ADDENDUM NO. 3

Project Name: **SR 60 and 43rd AVENUE INTERSECTION IMPROVEMENTS
(IRC-0853)**

Bid Number: **2019073**

This addendum is released to answer questions received to date, modify the bid documents and extend the deadline for receipt of bids. All information provided herein is hereby incorporated into the bid documents.

Sheet:	13
Of:	99
Project No.:	LHW# WP1027

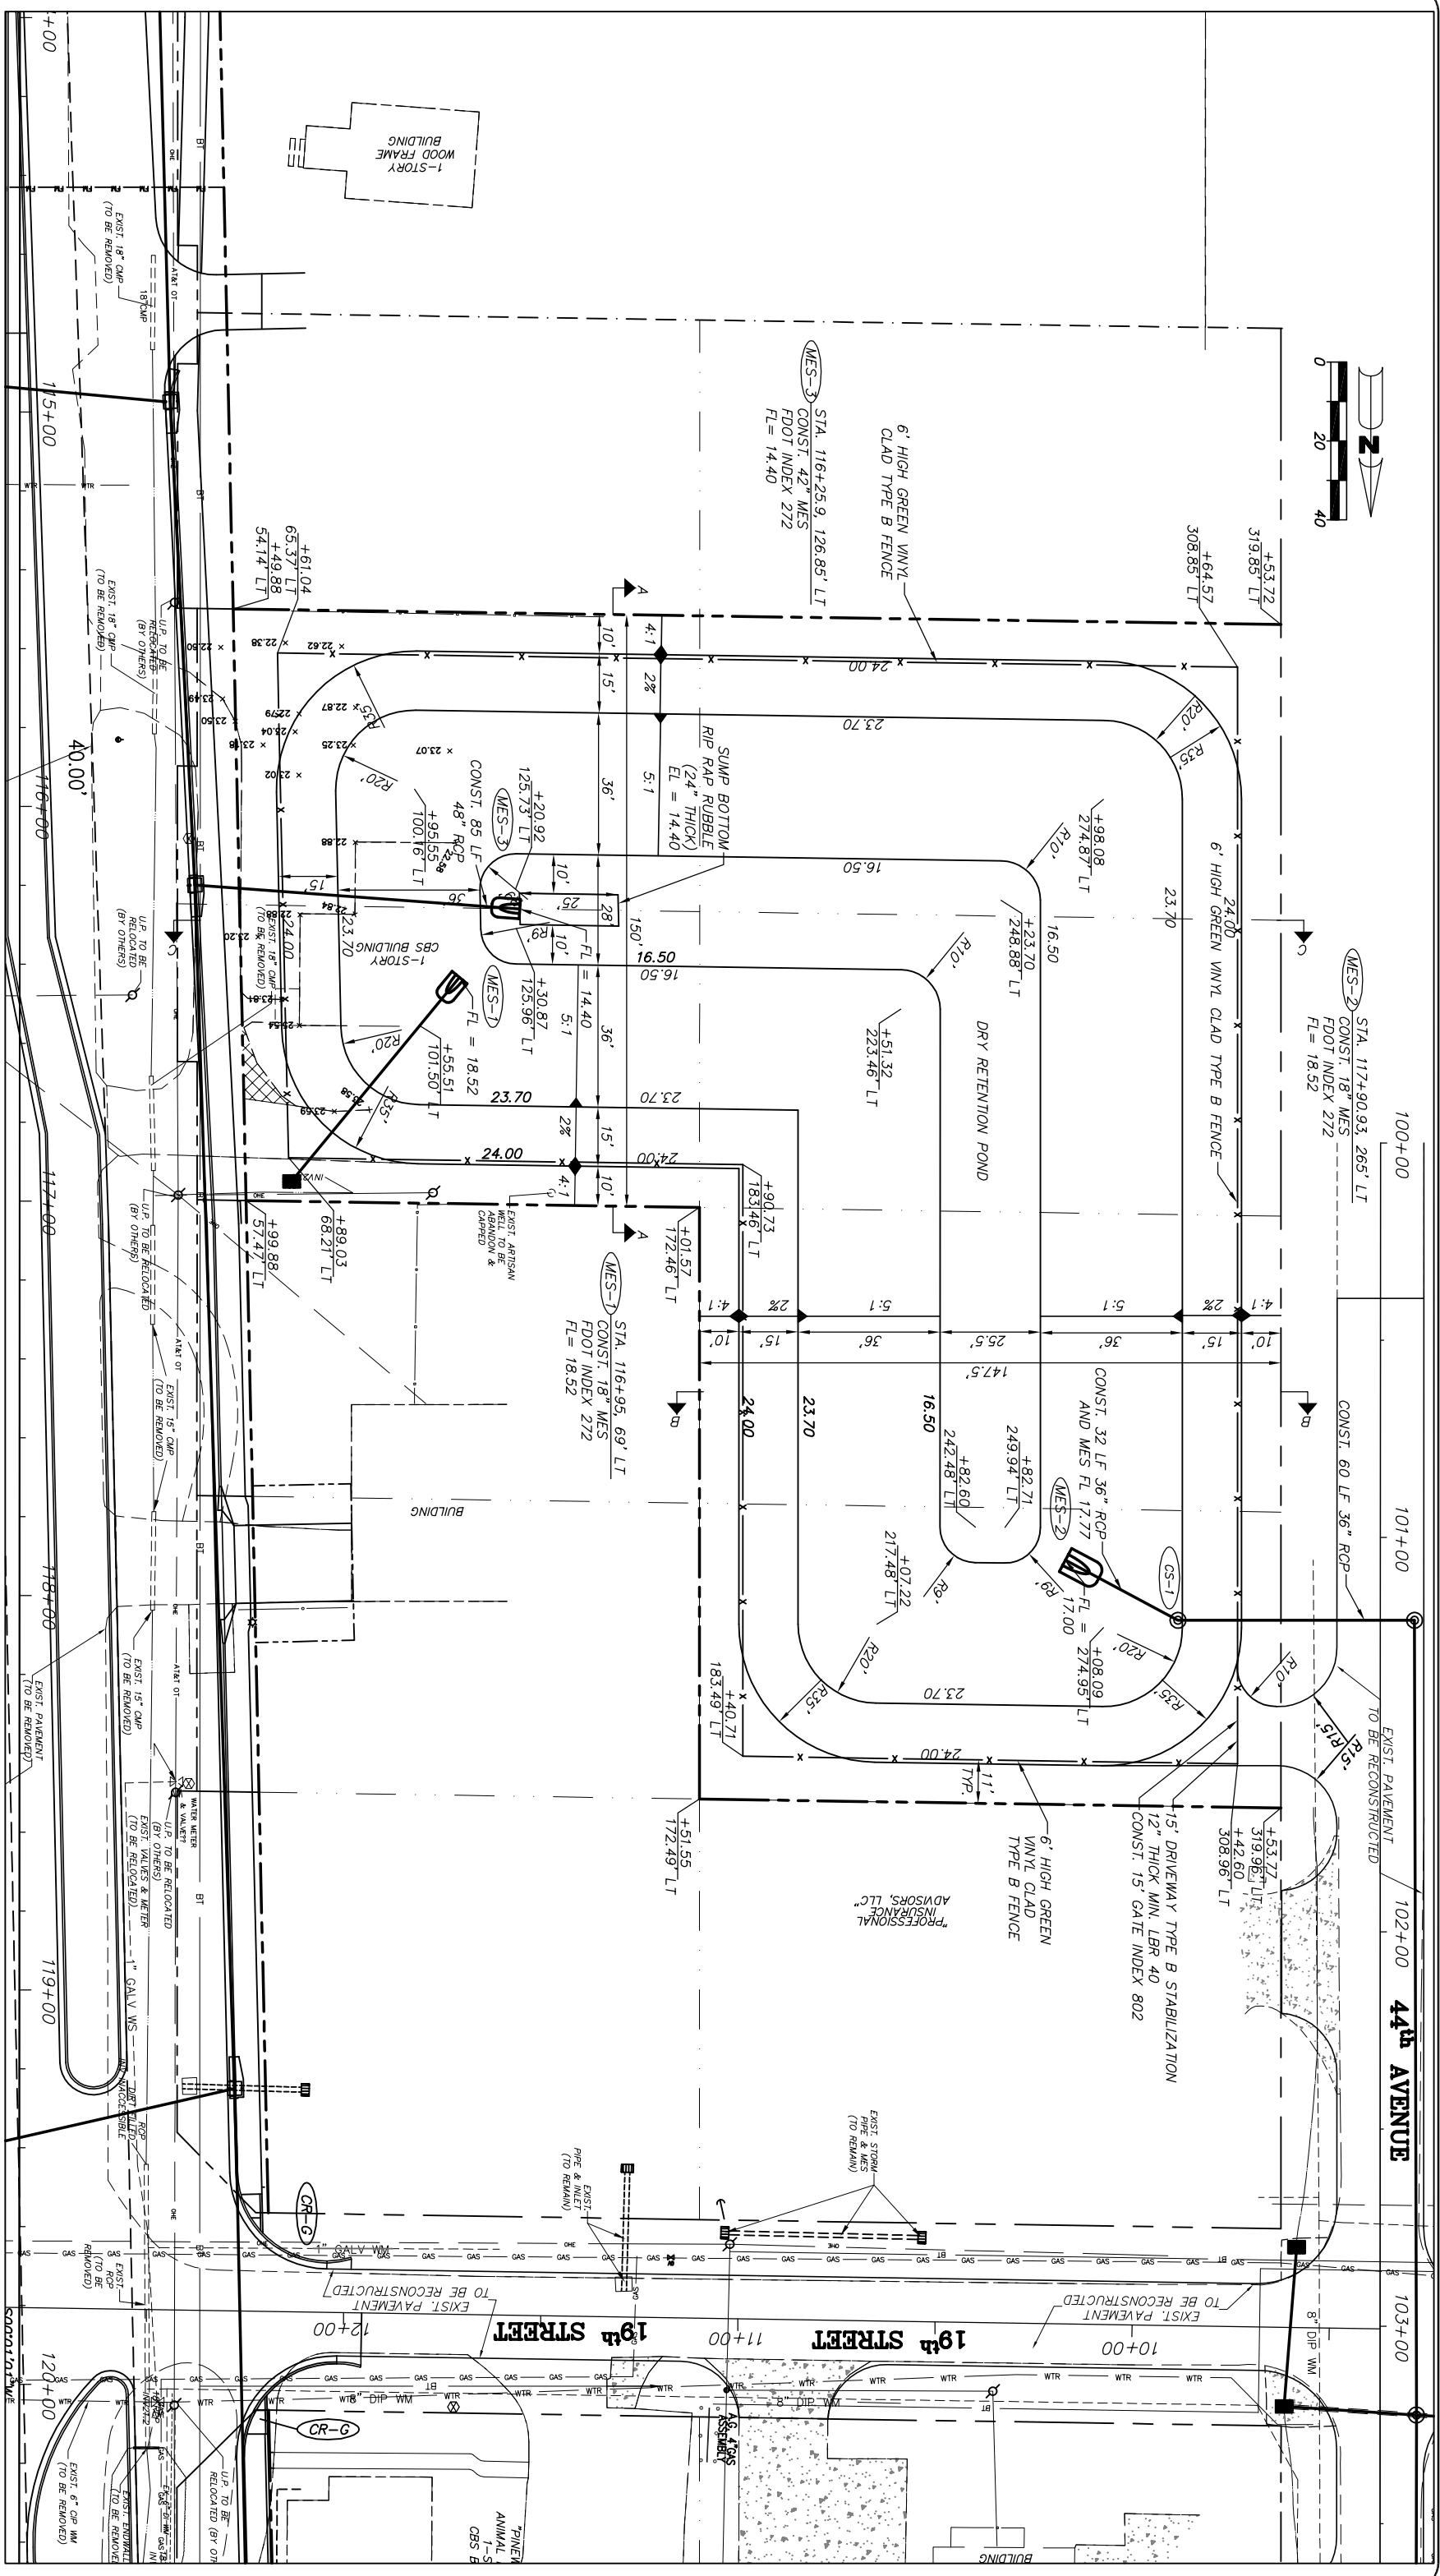
No.:	Revision:	By:	Date:
1	REVISED QUANTITIES	BFR	10/9/19

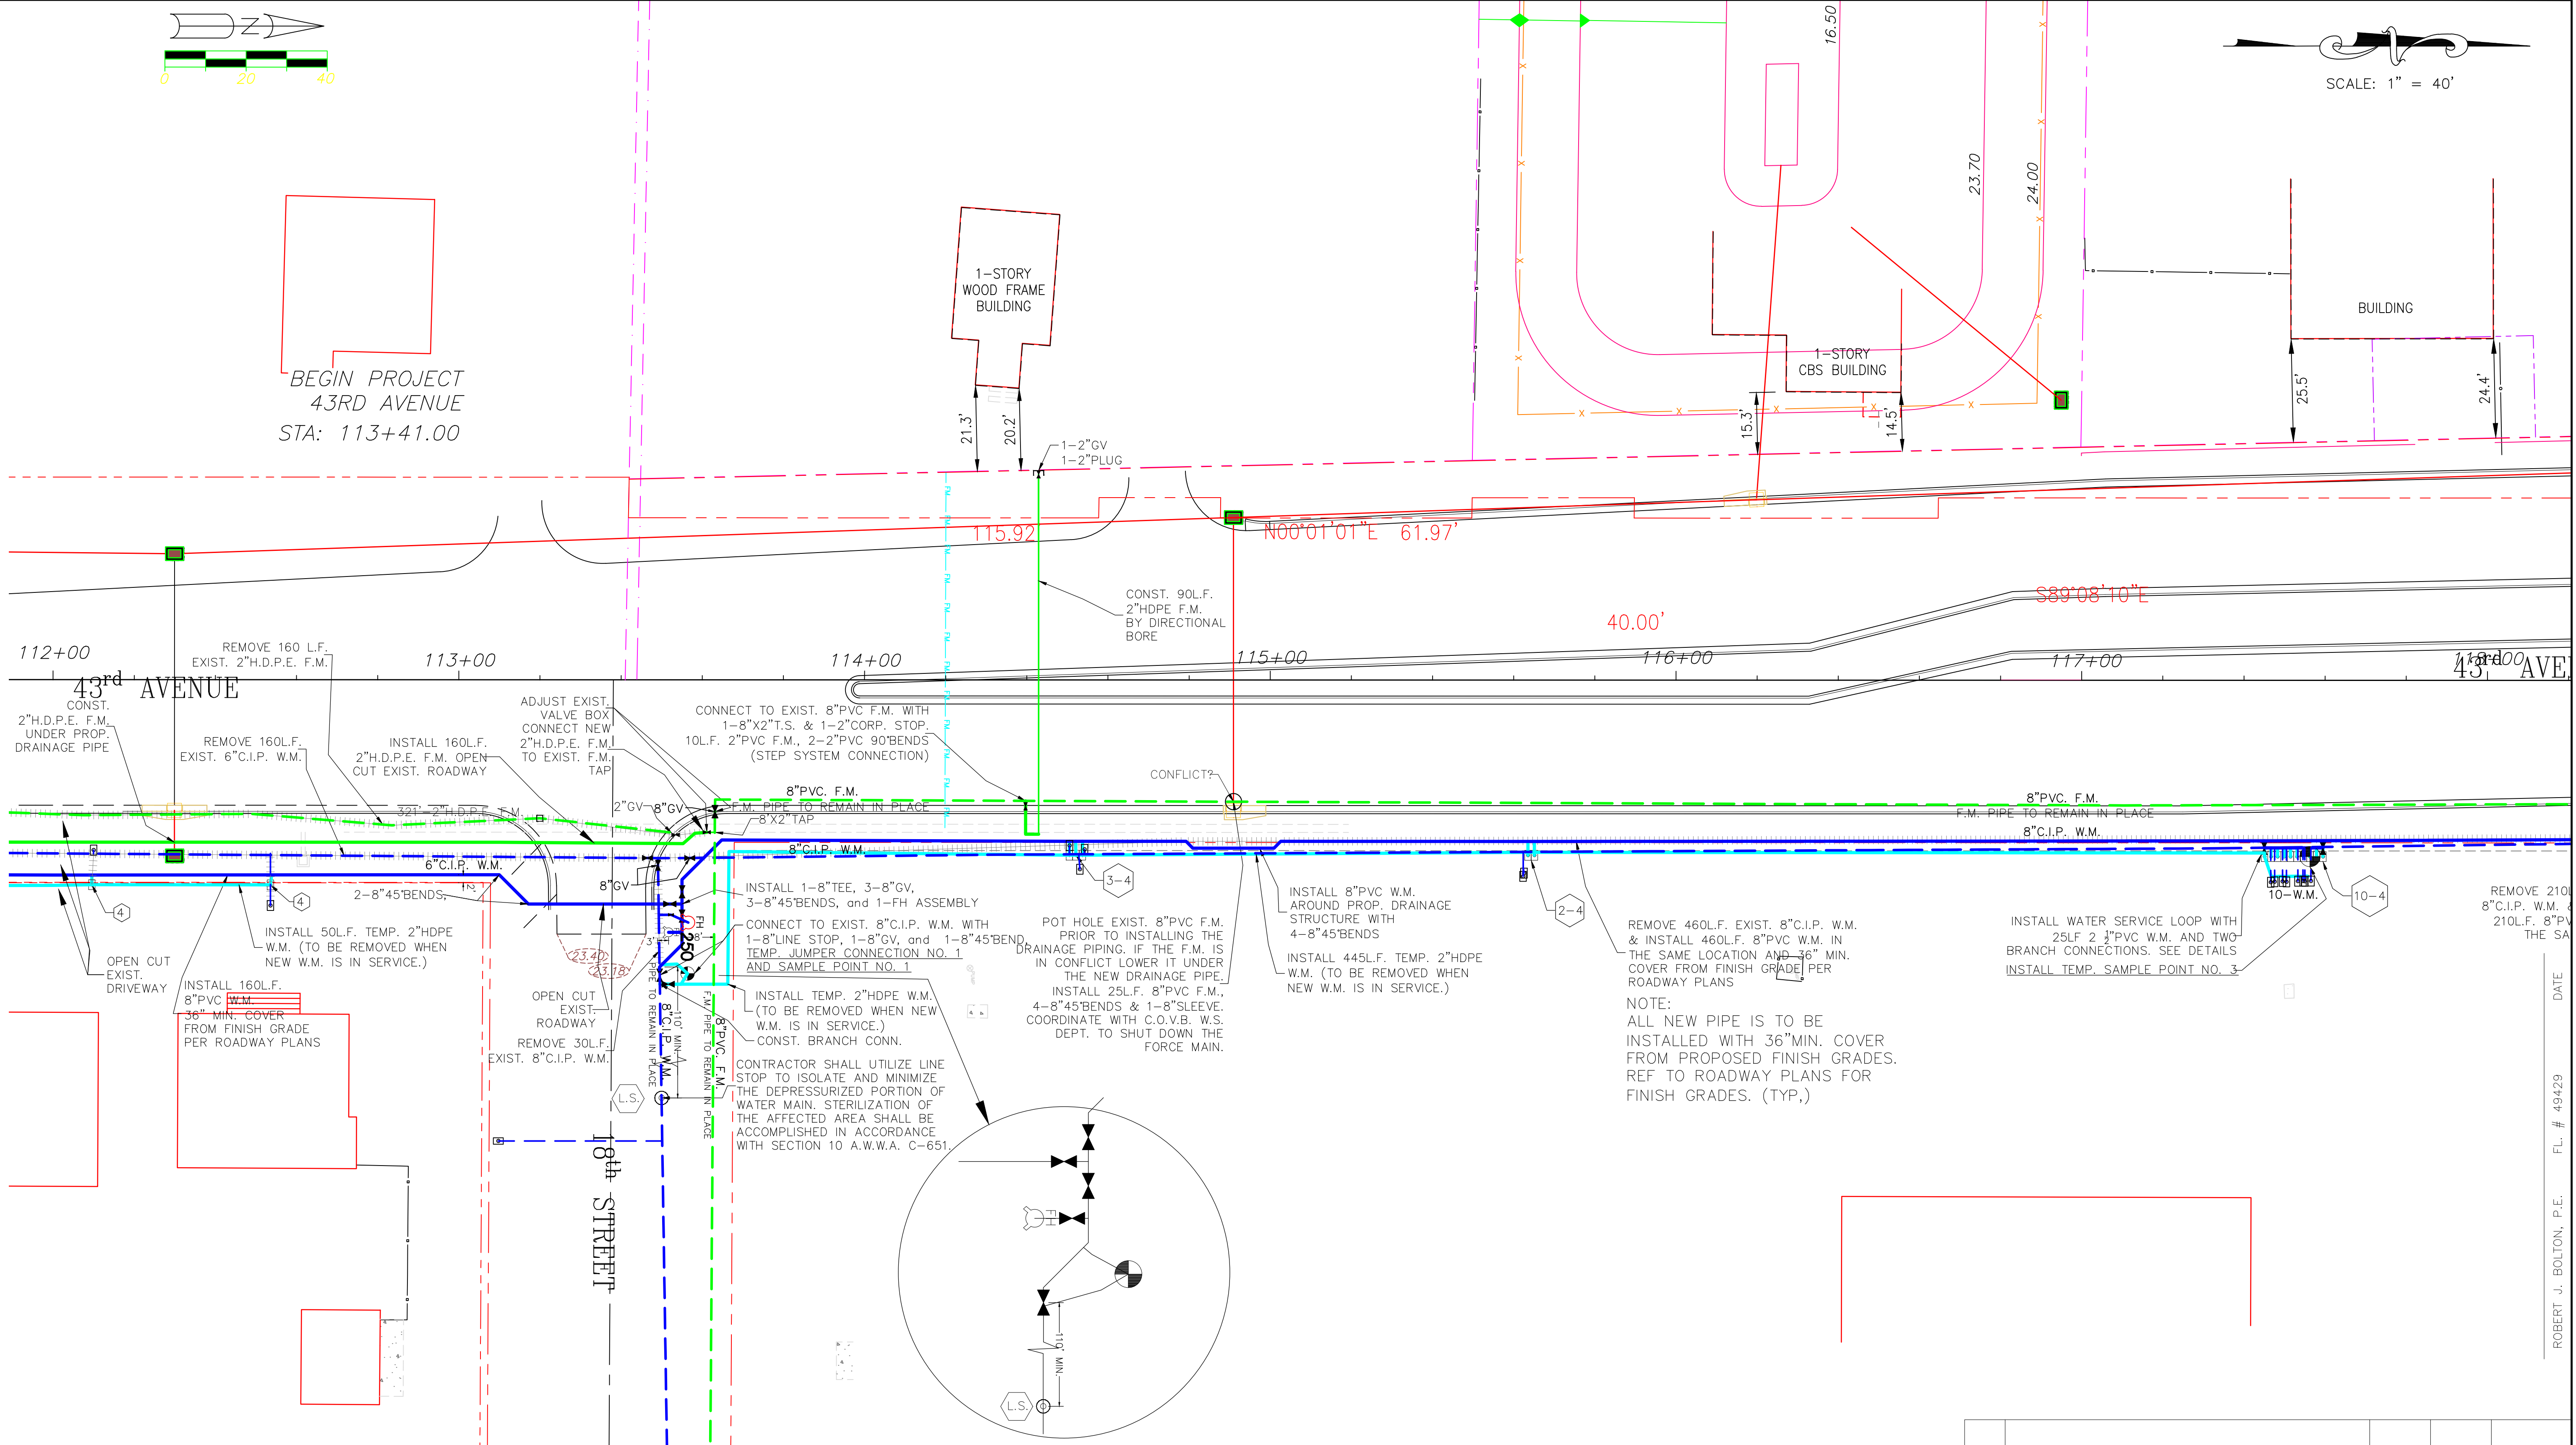
- Question 2.** On the City of Vero Beach Utility Relocation Plans, on plan sheet 2 of 58 the hatch legend for asphalt area to be open cut is used on side walk removal on plan sheet 11 of 58. Please clarify.

- Answer 2.** ***This is intended to note removal of the sidewalk is required.***
- Question 3.** Plan sheet 20 of 58 does not clarify what the legends are. Please provide additional information.
